# Wayzata Planning Commission

Date: April 1, 2016  
To: Planning Commission  
From: Jeff Thomson, Director of Planning and Building  
Subject: Development Application – UUCM, 2030 Wayzata Blvd E

**Planning Report  
Wayzata Planning Commission  
April 4, 2016**

**Project Name:** Unitarian Universalist Church of Minnetonka (UUCM)  
**File Number:** PR 2016-03  
**Applicant:** Wynne Yelland, Locus Architects  
**Property Owner:** Unitarian Universalist Church of Minnetonka  
**Addresses of Request:** 2030 Wayzata Blvd E  
**Prepared by:** Jeff Thomson, Director of Planning and Building  
**Planning Commission Review:** March 21, 2016  
**City Council Review:** April 19, 2016 (Tentative)  
**“60 Day” Deadline:** April 29, 2016

**3 ROOF PLAN**  
SCALE: 3/16" = 1'-0"

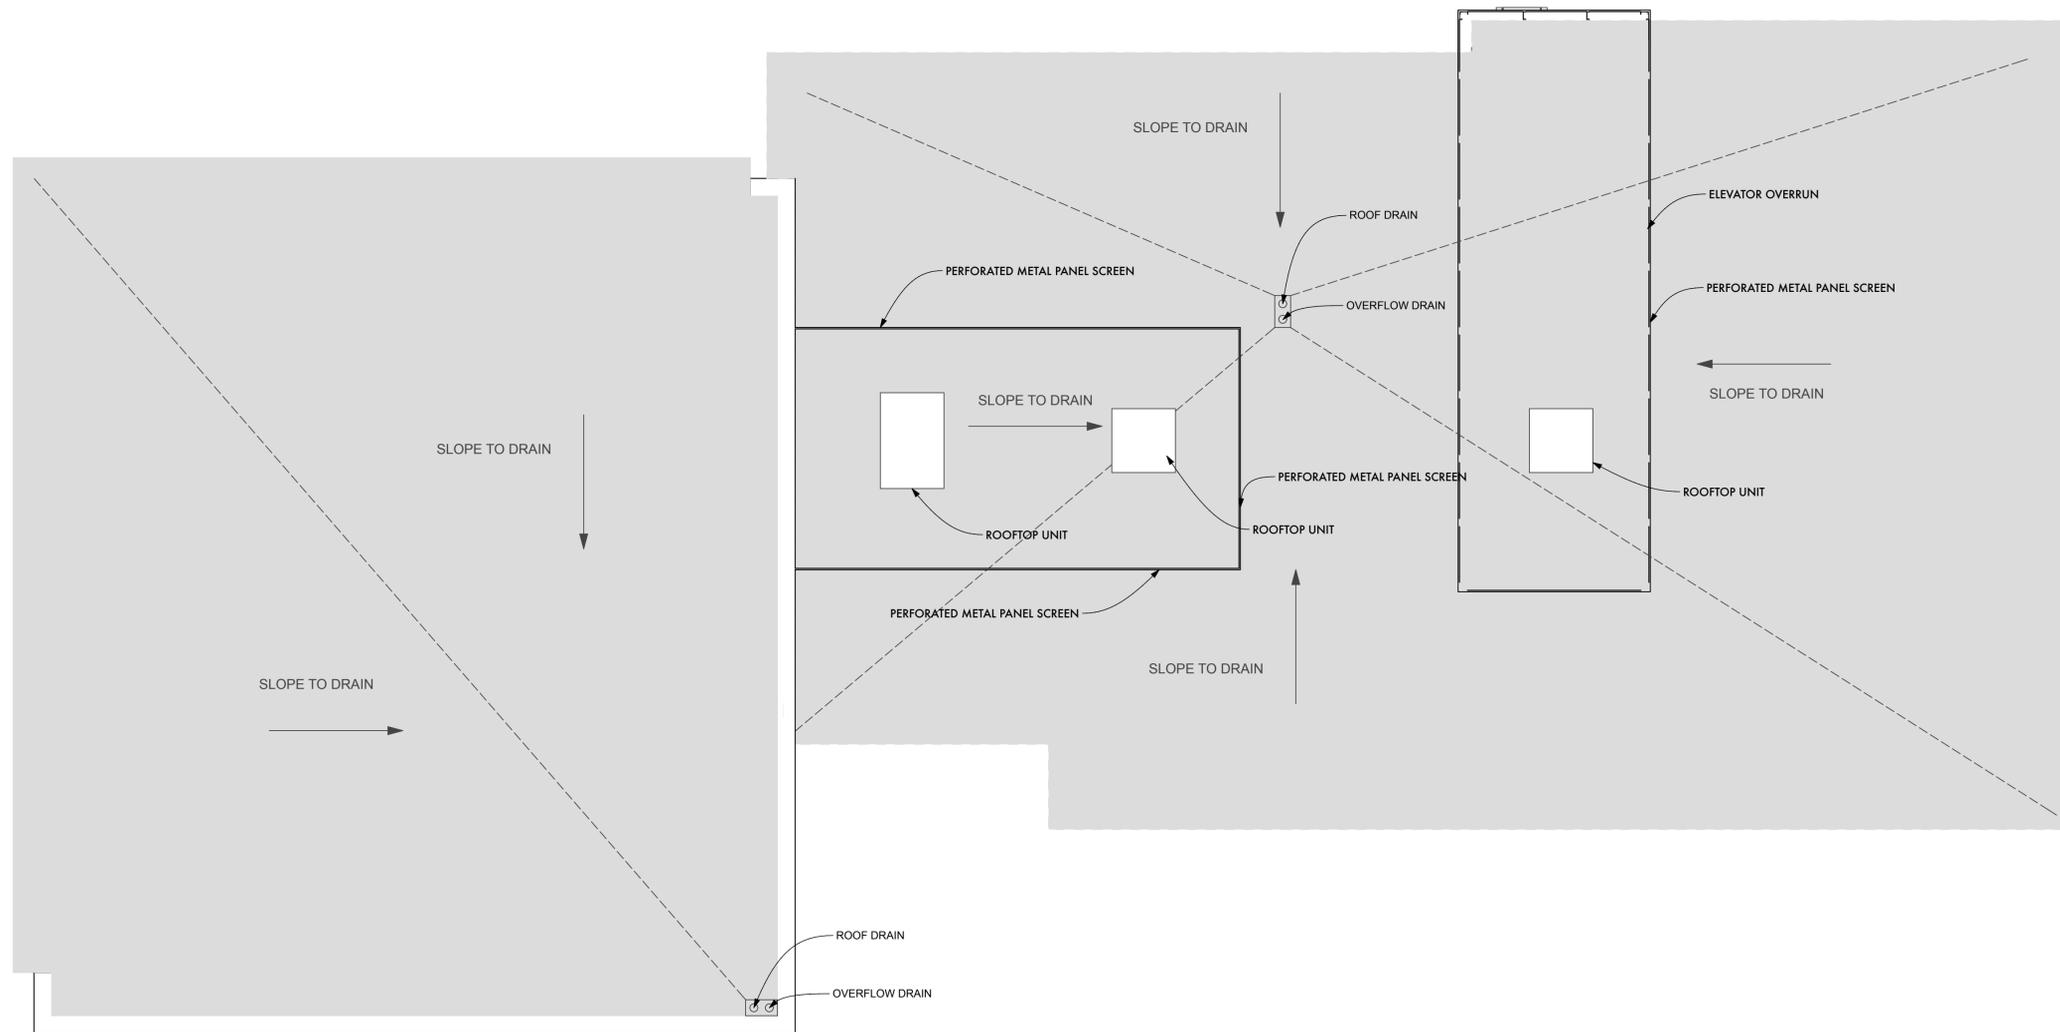
16  
17 Commissioner Gonzalez stated the applicant had referenced a light colored roof but the design  
18 standards require a dark color for the roof. She asked if the Commission would need to approve  
19 this deviation. Mr. Thomson stated that if the flat roof includes a light colored membrane, a  
20 deviation from the Design Standards would be required. Mr. Thomson asked that the applicant  
21 clarify what the roof color would be.

24  
25 Commissioner Gonzalez stated she appreciated the Applicant's willingness to comply with the  
26 City's proposed Tree Preservation Ordinance even though it has not been adopted yet. She  
27 stated she would like to ensure Mr. Jordan, the City Forester,'s questions and concerns are  
28 addressed by the Applicant. She asked what color the roof of the building would be.

8  
9 Mr. Morgan Truscott, 16400 Holdridge Road W, Wayzata, stated he would like the applicant to  
10 ensure the white roof could not be seen by the neighbors because he believes he would see it  
11 from the second story of his home. He also expressed concerns about the metal siding increasing  
12 the amount of noise because there would also be a significant amount of trees removed. He  
13 asked the Applicant provide the Commission with the exact amount of fill that would be brought  
14 to the site. He expressed concerns with the white exterior of the building because this does not  
15 meet the Design Standards for the City. He asked what the elevation for Parcel B would be  
16 because he does not think a parking lot would work in this area.

- Visibility of the flat roof from surrounding properties: The applicant has provided a cross-section drawing that shows the roof elevation of the church and the elevation of the homes along Holdridge Road West.

**1** PROPOSED WALL SIGN AT ENTRY  
SCALE: 1" = 1'-0"

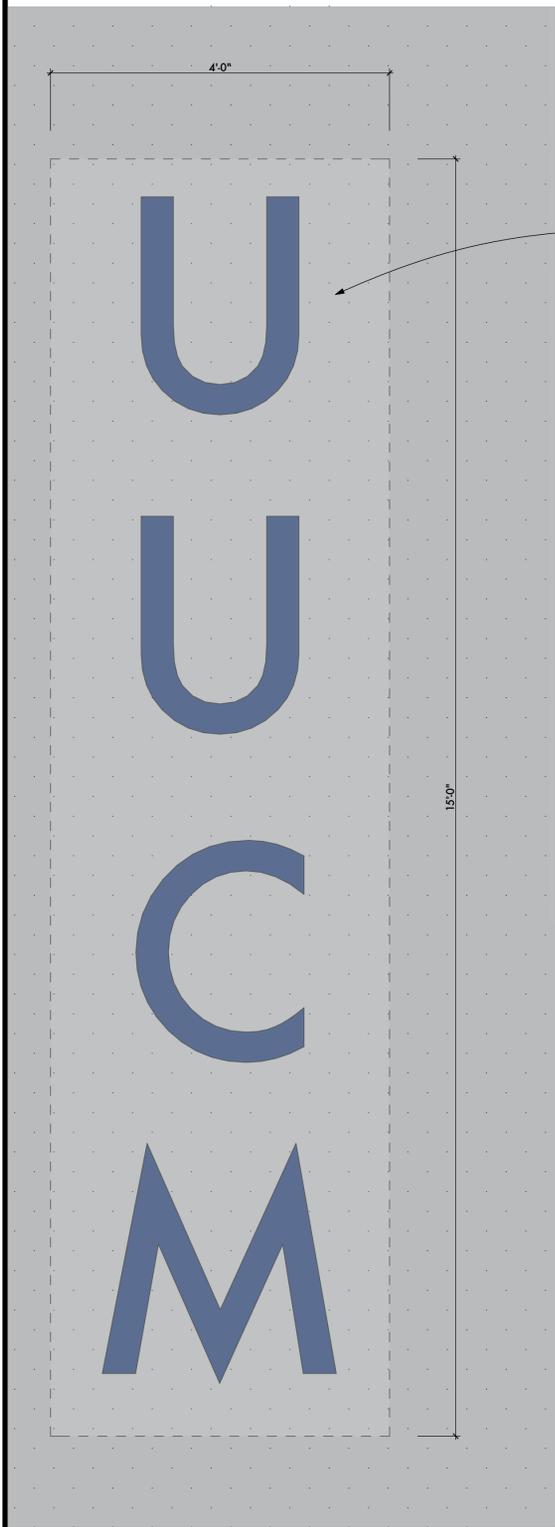
28  
29 Commissioner Gonzalez stated the metal siding presented would not be appropriate. If it would  
30 be masked in some way, such as a more appropriate color to keep the building from standing out,  
31 it may be something the Commission could consider. She stated one of the conditions of  
32 approval in 2012 had involved screening with berms, trees, and other plantings to protect the  
33 neighborhood. She stated the City's Code for lighting requires downcast lighting, and  
34 information on how this lighting would be screened from the neighborhoods. She stated the  
35 Applicant would need to submit a lighting plan including information on hours of operation. She  
36 stated the City's Ordinance does not allow backlit signs, and the Applicant is proposing a backlit  
37 sign.

- Lighting of exterior signage: The revised plans submitted by the applicant indicate that the monument sign along Wayzata Boulevard East would be externally lit with full cutoff

The sign ordinance requires that all artificially illuminated signs in non-residential districts adjacent to a residential district must be turned off at the close of business or by 10:00 p.m., whichever occurs later. City staff is recommending that this be included as a condition of approval in the draft Planning Commission Report and Recommendation.
